MORTDALE RESOURCE RECOVERY FACILITY

BINGO INDUSTRIES PTY LTD MORTDALE RESOURCE RECOVERY FACILITY

Response to Submissions

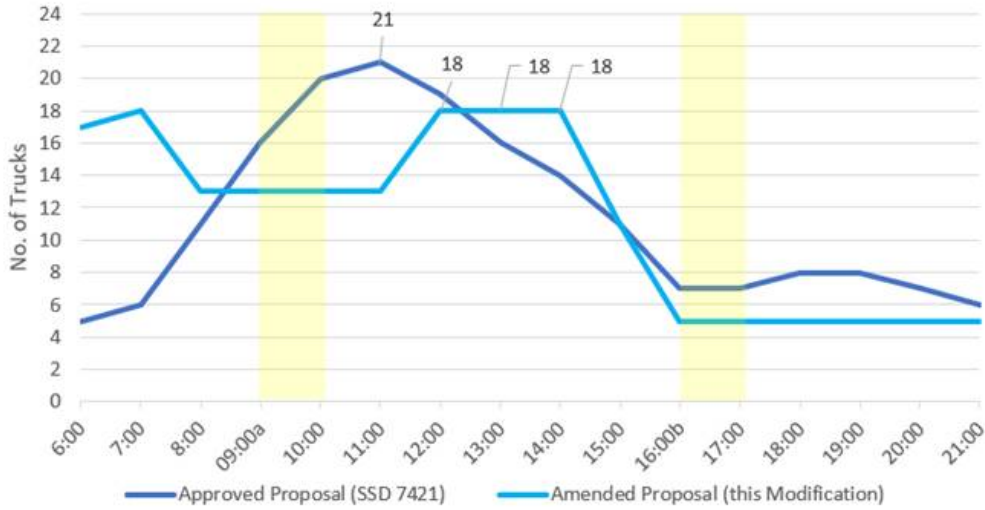
Submission text	Response	Reference																														
Department of Planning and Environment																																
Traffic and Transport:																																
a. Please confirm what utes would be accessing the site (p.41). Would members of the public be accessing the site?	A small percentage of light vehicles accessing the site would consist of utes and cars including members of the public. The Modification Proposal would not alter the types or number of vehicles as approved within the Current Approval.	-																														
b. The figures in Table 6-4 and Figure 6-1 do not correspond. Please confirm the number of vehicles which are anticipated in the hourly traffic profile (p. 42).	<p>The number of vehicles anticipated to access the site on an hourly basis under the Modification Proposal scenario has been provided in Table 6-4 of the Modification Report (reproduced below) and is show in the figure below.</p> <p><i>Table 2-1 Comparison of the hourly profile from the Current Approval to the Modification Proposal</i></p>

Figure 6-1 provided a comparison of the hourly traffic profile under the Modification Proposal with the 'existing' traffic profile i.e. the profile prior to the implementation of the Current Approval. The numbers associated with that profile were not shown within Table 6-4 (however, they were detailed within the Amended Traffic Impact Assessment). Figure 6-1 has been updated below to show the hourly profiles for the Current Approval (SSD 7421) and the Modification Proposal (as detailed in Table 6-4).

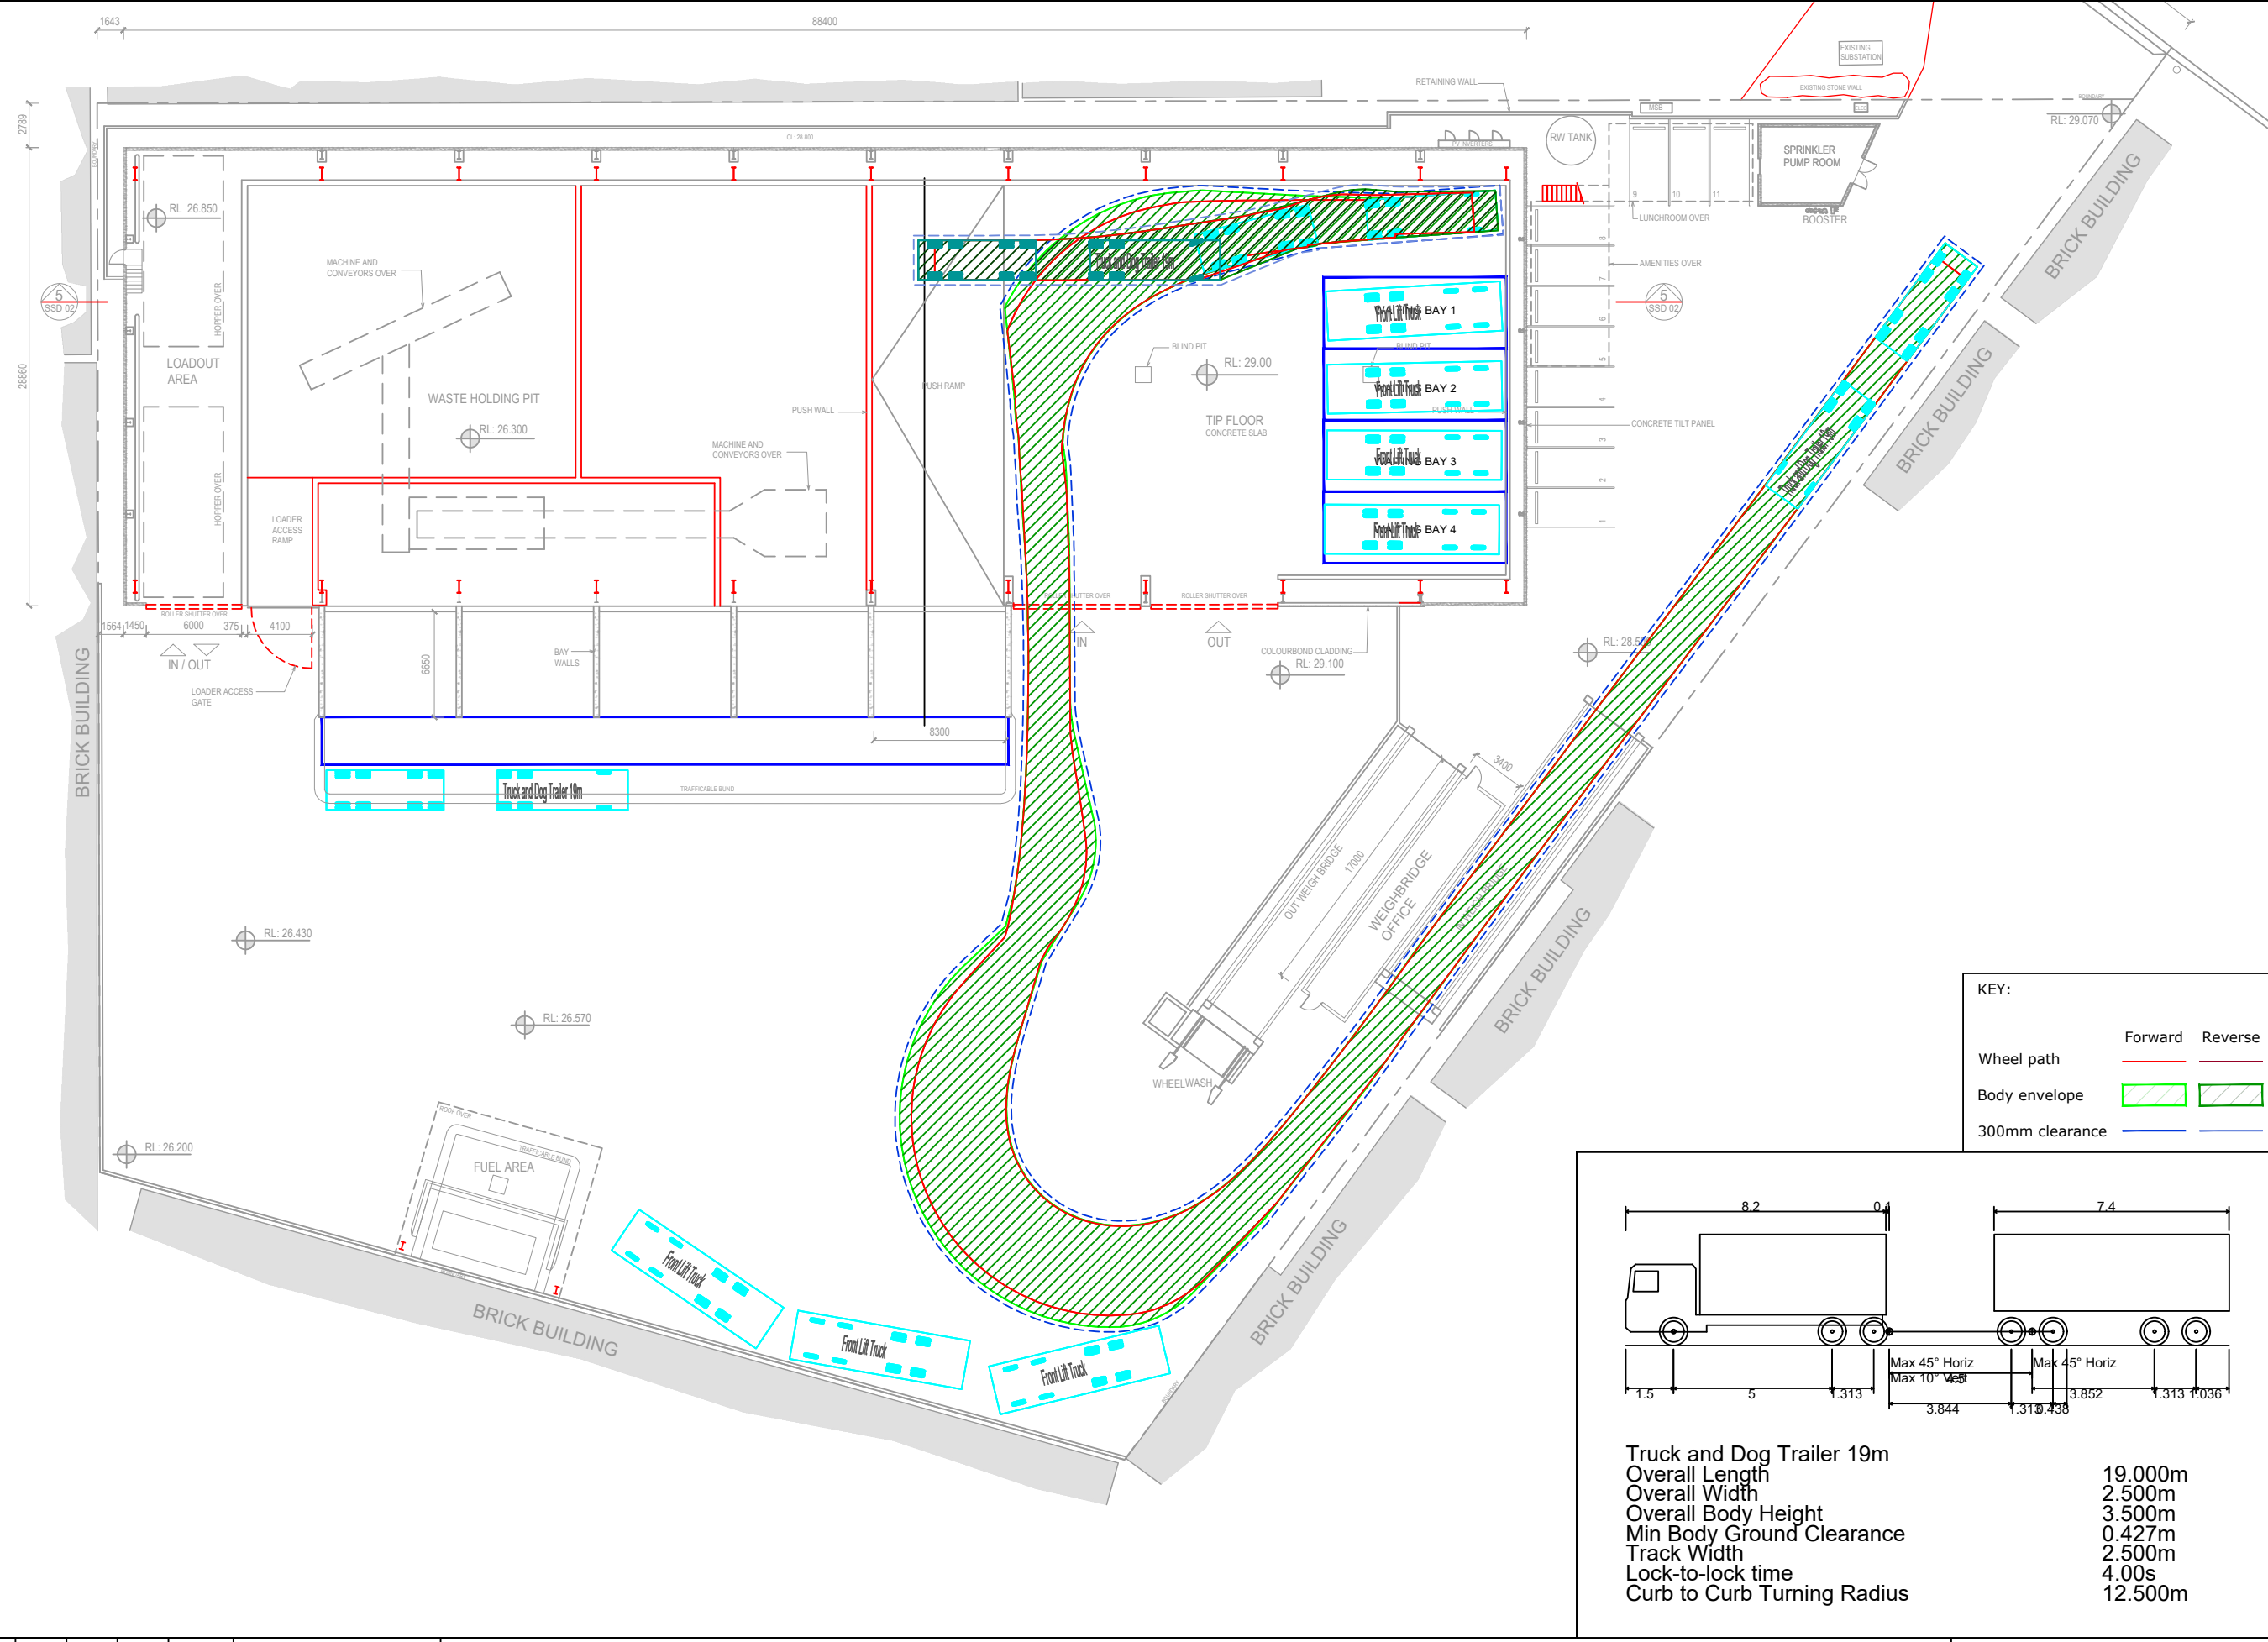
Submission text	Response	Reference
In the design for the amendments to the site, we would like confirmation the access and manoeuvring will not result in the loss of any on street carparking spaces.	Stacking spaces have been positioned outside of the path of travel for all vehicles entering and exiting to enable vehicles to manoeuvre safely around the site even during peak periods. Updated swept paths have been provided in Appendix A of this document to also show stacking spaces.

PROJECT	BINGO MORTDALE	
TITLE	19m TRUCK & DOG TRAILER VEHICLE SWEEP PATH ANALYSIS INBOUND WEIGHBRIDGE - DROP/ TIP AREA

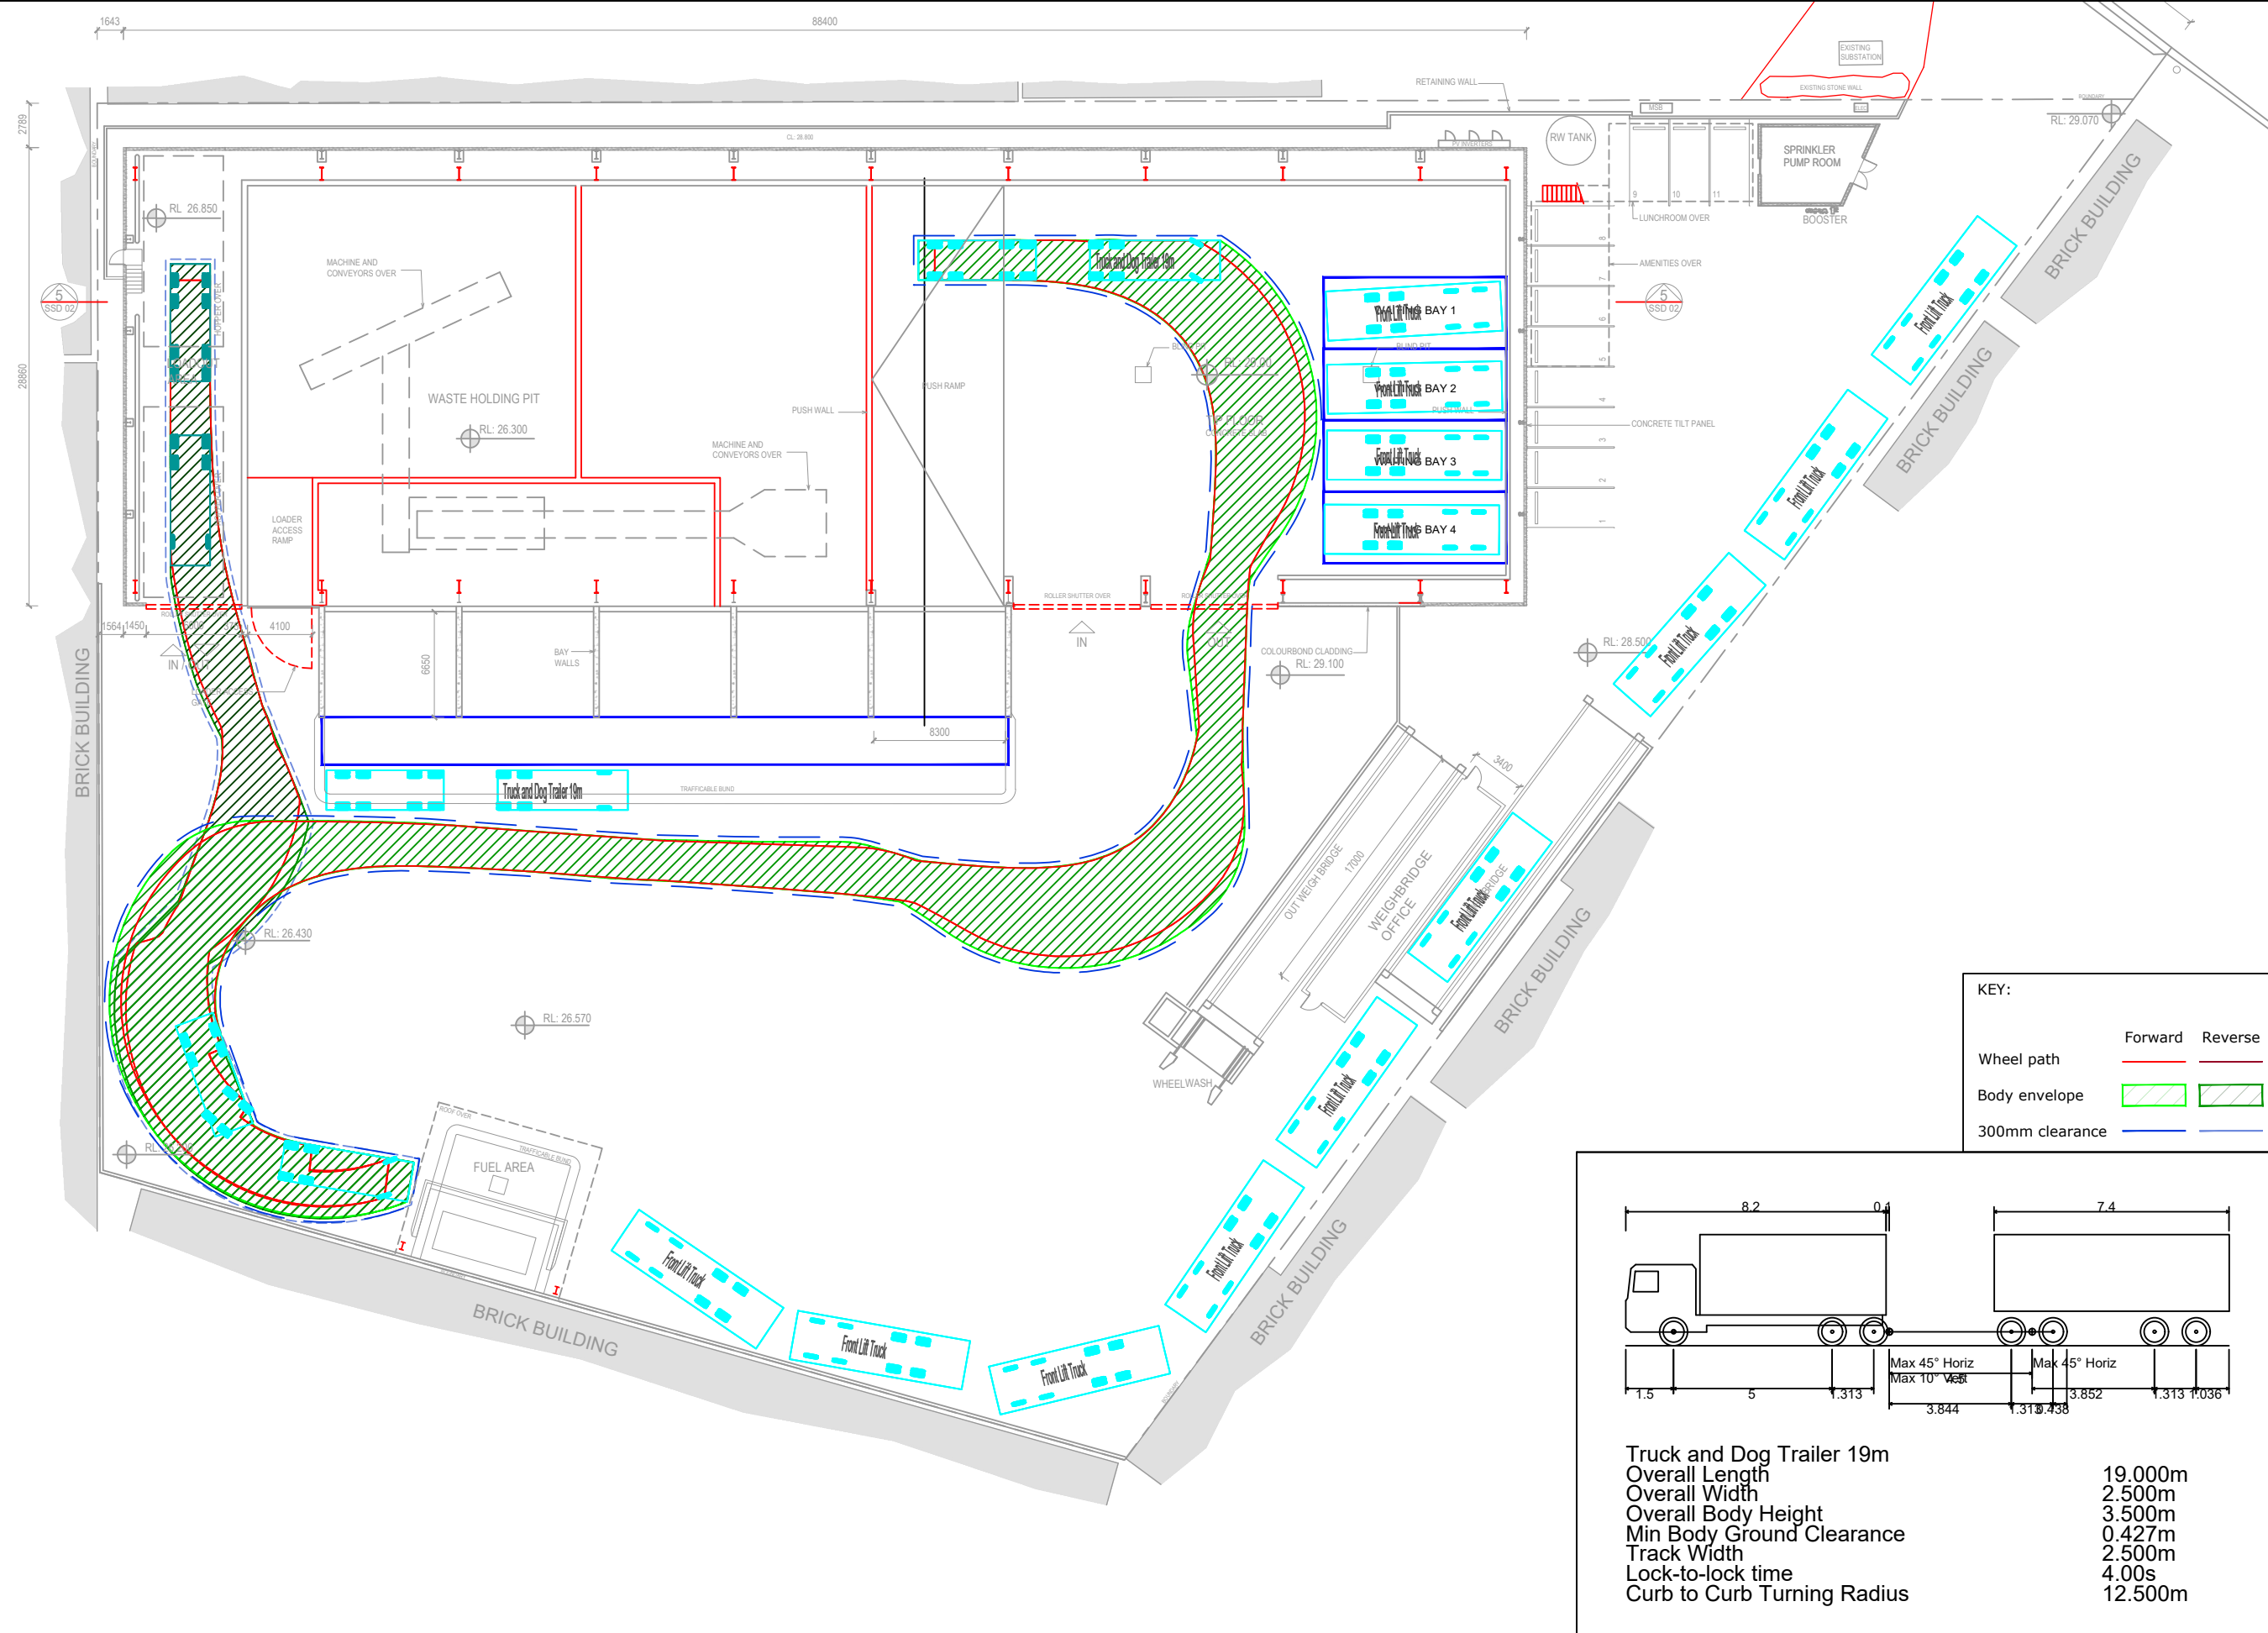
<p>f. Please show how the number of trucks (deliveries and collections) in the busiest hour would be able to access the site under worst case scenario without queuing on the local road network, this should include how swept paths will be maintained and trucks can exits the site if trucks are using stacking spaces under normal and worst case scenarios.</p>	<p>A summary of on-site stacking including an assessment of the typical and worst-case scenarios has been included in section 6.8.2 of the Modification Report and is detailed in the Amended Traffic Impact Assessment (Appendix E of the Modification Report). Figure 6-3 shows that even under the worst-case scenario in the busiest hour, the 18 trucks would be adequately accommodated across 8 stacking spaces, leaving seven stacking spaces remaining which could accommodate a potential overflow of vehicles in the event of an incident occurring.</p> <p>In all scenarios shown (typical and worst case) there are vacant stacking spaces available within the stacking channel and on-site stacking would extend beyond the weighbridge office that is on-site. Therefore, in the busiest hour, all trucks predicted to arrive at the site would be accommodated wholly on-site and would not be required to queue onto the local road network.</p> <p>Stacking spaces have been positioned outside of the path of travel for all vehicles entering and exiting to enable vehicles to manoeuvre safely around the site even during peak periods. Updated swept paths have been provided in Appendix A of this document to also show stacking spaces.</p>	<p>Section 6.8.2 of the Modification Report Appendix E of the Modification Report</p>

<p>g. Please clarify whether vehicles will be reversing or driving into the bunker area or both (p.44).</p>	<p>Normal operations would require vehicles to reverse into the bunker area. Swept paths have been included in Appendix E of the Modification Report (Amended Traffic Impact Assessment) and</p>	<p>Appendix E of the Modification Report</p>

Submission text	Response	Reference
	updated in this document (Appendix A of this document). These swept paths demonstrate that the reverse in manoeuvre can be undertaken safely.	Appendix A of this document
Air Quality: a. Clarify whether Table 6-2 includes the reduction in air emissions from material sorting as set out in the proposed modification. Provide source for figures in Table 6-2 (NB this table does not appear to be in Appendix D).	<p>The estimated annual emission rates for the Modification Proposal, as presented in Table 6-2 of the Modification Report include reductions in air emissions from material sorting and reduced throughput (compared to the 300,000 proposed within the original EIS).</p> <p>It is noted that a superseded version of the Air Quality Assessment (prepared by Wilkinson Murray) was erroneously appended to the Modification Report. The correct version of the Air Quality Assessment has been included as Appendix B of this document. This version includes further detail on the emissions rate and control factors relating to information summarised in Table 6-2.</p>	Appendix B of this document
